Havant Thicket Reservoir

Phase 7 & 8 – Landscaping and Discharge Structures

HBC ref: App/26/00679

EHDC ref: EHDC-26-1027

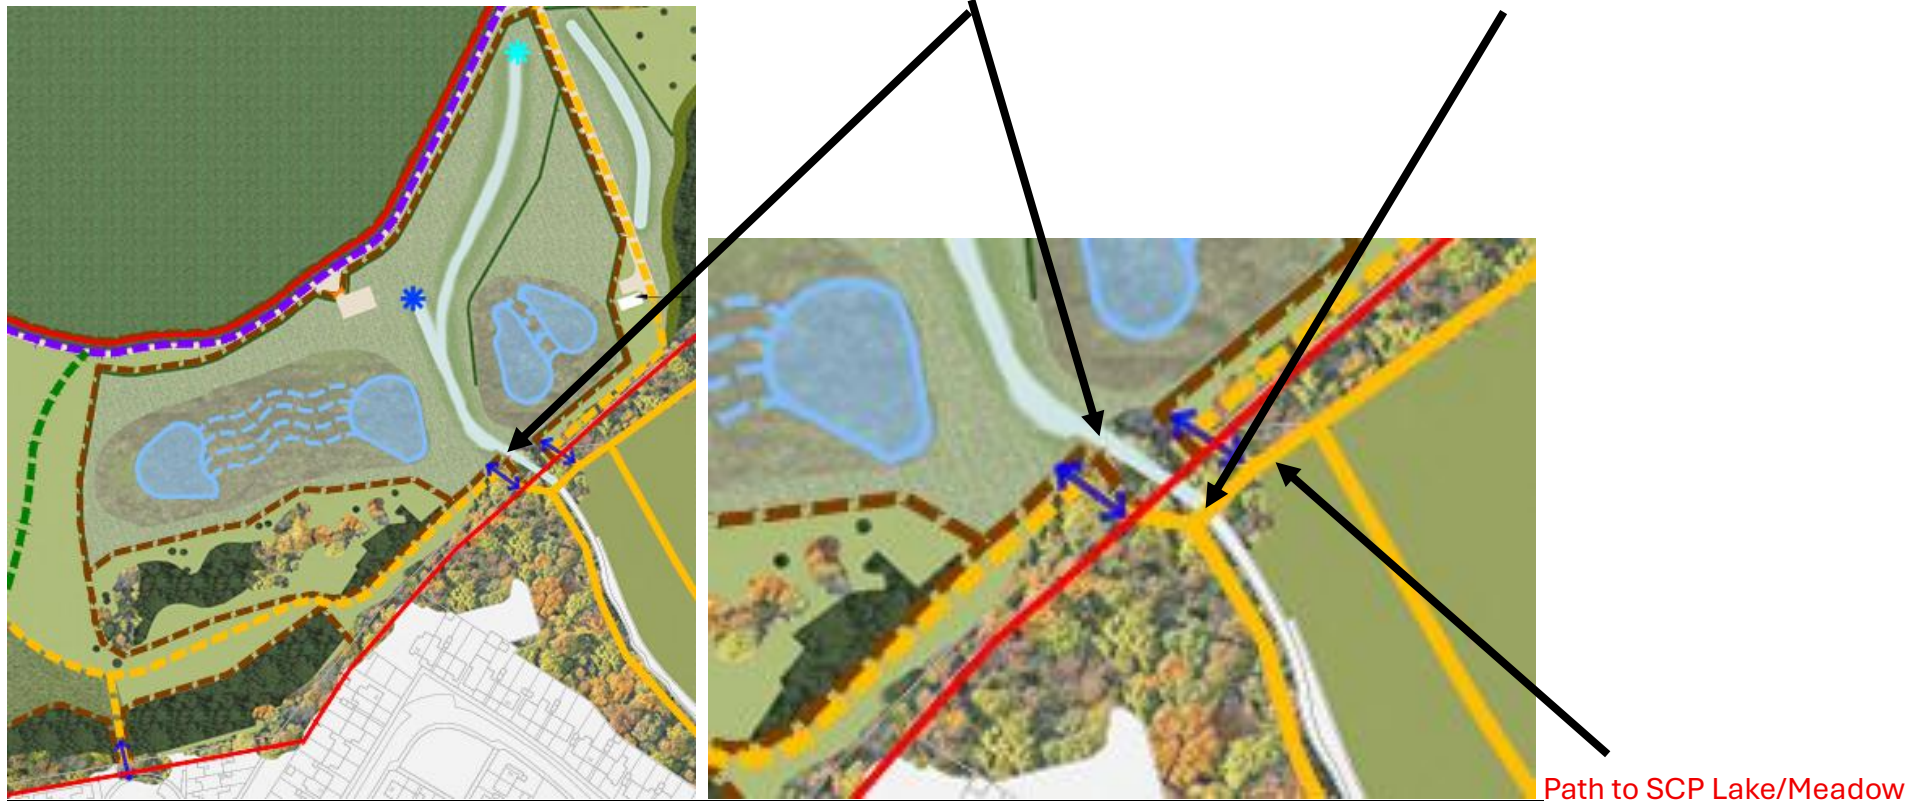
A further area of the advanced planting missing from the Amended Eastern Section drawing is the 6m wide rectangular area adjacent to where Cedar Drive enters the woodland'. Advanced tree planting was undertaken both north and south of the Durrants Stream to improve connectivity, with parkland standards also planted south of the stream which are not shown.

The advanced tree and hedgerow planting was approved in writing by both LPA's (East Hants District Council and Havant Borough Council) to enable the early establishment of new habitats, and to enhance the eastern wildlife corridor which was essential due to the loss of The Avenue woodland corridor. The planting is integral to the scheme and must be retained and maintained in future by the applicant. The missing areas of advanced planting and hedgerows must be added to the Phase 8 drawings before the application is approved.

Extract of workshop presentation slide – Operational details (extract) -pdf page 39 (Statement of Community Involvement) shows the alignment of the pipes between the Control House and Round Wood

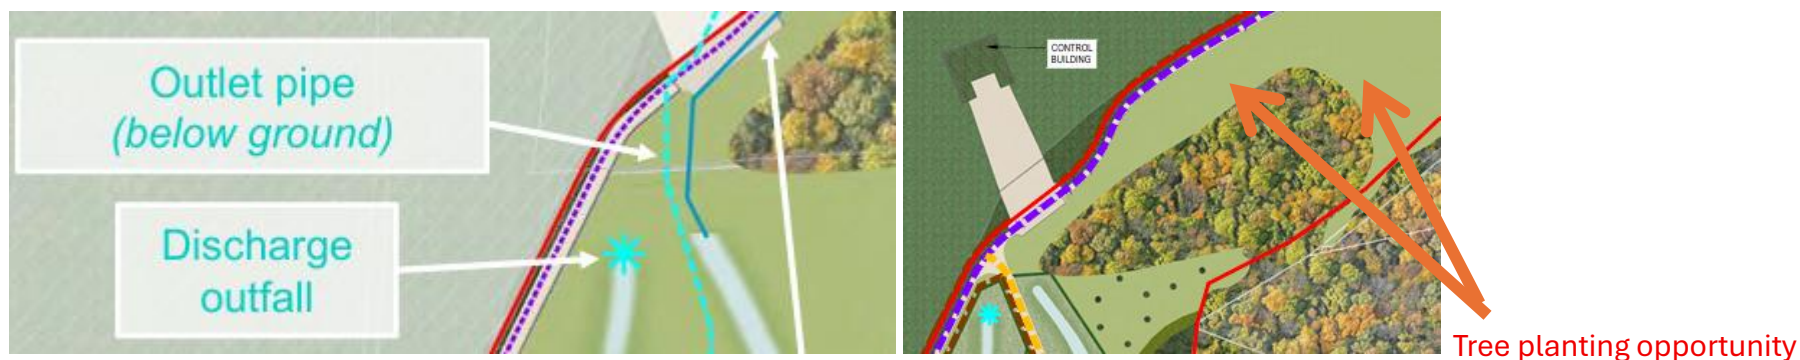
There should be space to plant trees immediately to the NE and east of Round Wood (see orange arrows) to restore ancient woodland and create a transitional edge habitat that would be beneficial for wildlife and create a more natural graded landscape, while avoiding the underground pipework. The LPA should request that the applicant give this further consideration.

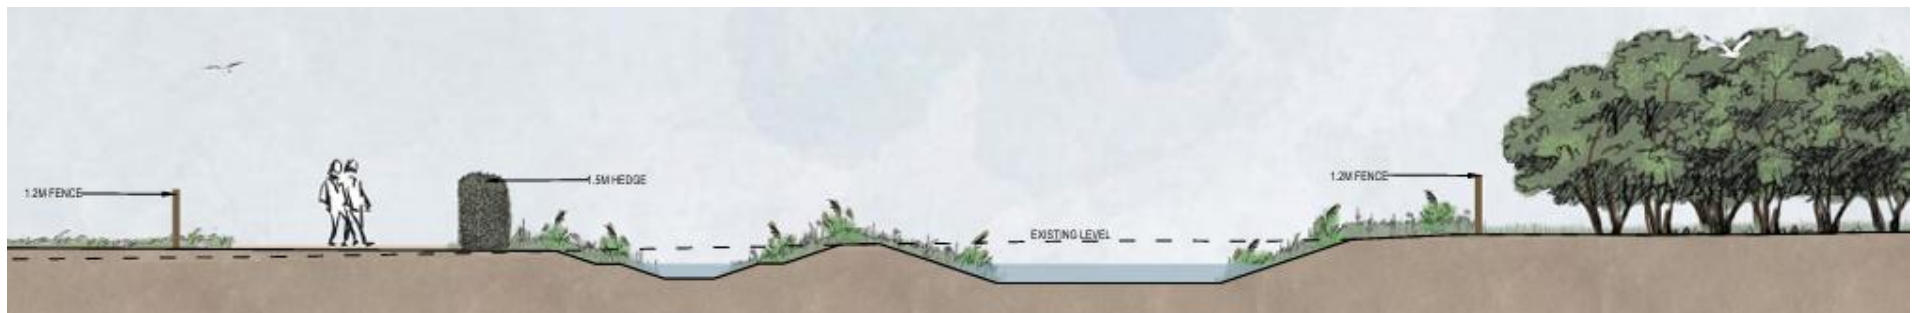
There is also reference on the sections to existing advanced planting areas which are currently protected by 1.8m high deer fences with stockmesh **being replaced by 1.2m fences**. For example, REALIGNED DURRANTS STREAM CROSS SECTIONS R52-R52' extract below shows the Gipsies Plain Phase 1 woodland corridor protected by a 1.2m fence, not the existing 1.8m deer fence.

The existing deer fences protecting the advanced planted areas should only be replaced when they are at the end of their useful life and the trees within are well established. Despite construction activities deer are still present at the site, 2 were seen just outside deer fenced advanced planted areas on 7/10/26, and deer will quickly re-establish in larger numbers once the construction work is complete. Planted areas must be protected from deer grazing to enable the trees to establish.

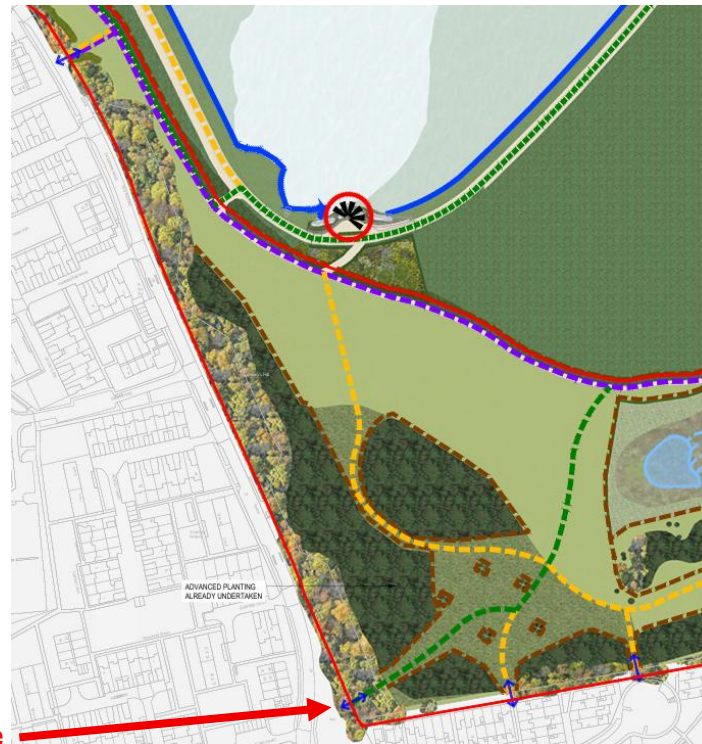
Following pre-application engagement with Hampshire Highways, it is considered that further dialogue and alignment with the site wide Recreation and Access Strategy from the reservoir is required before the final details of access management measures at entrances to the site can be agreed. These details have therefore not been included in the RMA application, with the exception of two kissing gates which provide access to Well Meadow residential area to the south west of the site.

Instead, it is proposed that a planning condition is attached the Phase 7 & 8 RMA requiring the details of access management measures at entrances to the site where not included on the approved drawings to be submitted to and approved by the local planning authority prior to the reservoir site opening to the public. This will enable the final approach to be informed by the outcome of further stakeholder discussions and equality considerations, including compliance with the Equality Act 2010, and ensure there is alignment with the reservoir-wide Recreation and Access Strategy.
